PLANNING AND ZONING CASE CHECKLIST

P&Z CASE # SP2019-005 P&Z DATE 2/20/19 CC DATE 3/12/19 APPROVED/DENIED _____
ARCHITECTURAL REVIEW BOARD DATE _____ HPAB DATE _____ PARK BOARD DATE _____

Project Number: SP2019-005
Project Name: Saddle Star South
Project Type: SITE PLAN
Applicant Name: SADDLE STAR LAND DEV. LLC
Owner Name: R, & R HANCE INVESTMENTS LP
Project Description:

Project Number	SP2019-005	Owner	R, & R HANCE INVESTMENTS LP	Applied	2/19/2019	LM
Project Name	Saddle Star South	Applicant	SADDLE STAR LAND DEV. LLC	Approved		
Type	SITE PLAN			Closed		
Subtype	PD			Expired		
Status	P&Z HEARING			Status	2/21/2019	DG

FRONT VIEW

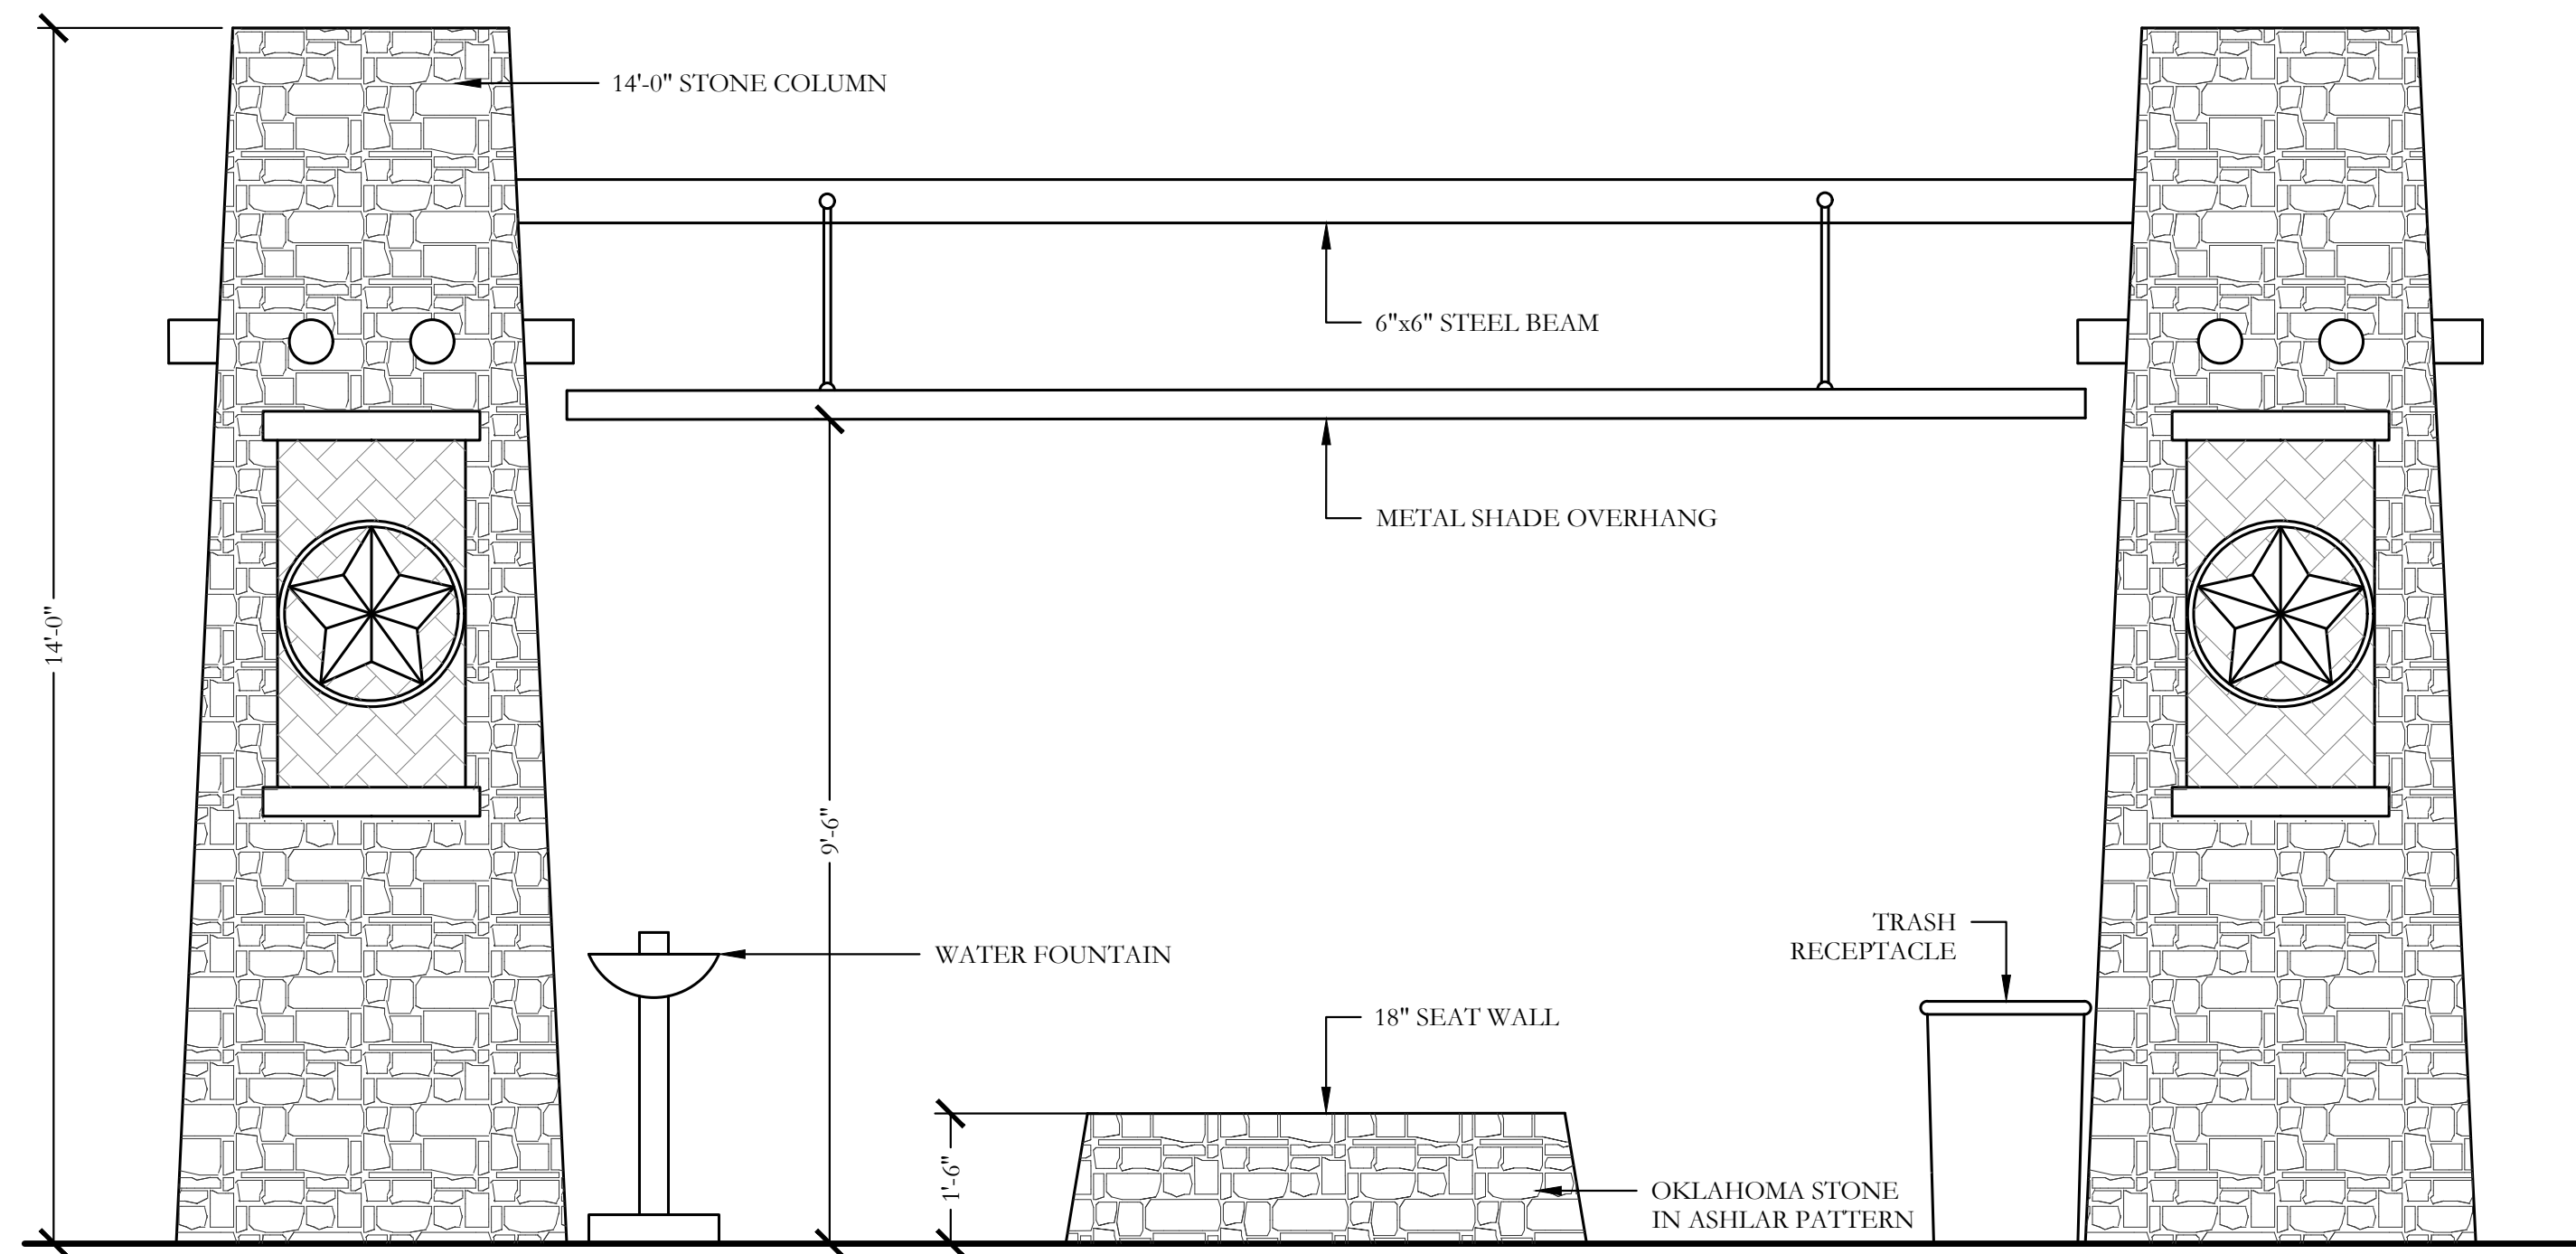
3. Fence detail needs to indicate wrought iron or tubular steel fencing materials Fence columns to be spaces at 45-ft O.C.						
4. Street names to match PD Site Plan. Names to be approved by the GIS Department (Lance Singleton, GIS Supervisor).						
Landscape/Treescape Plan:
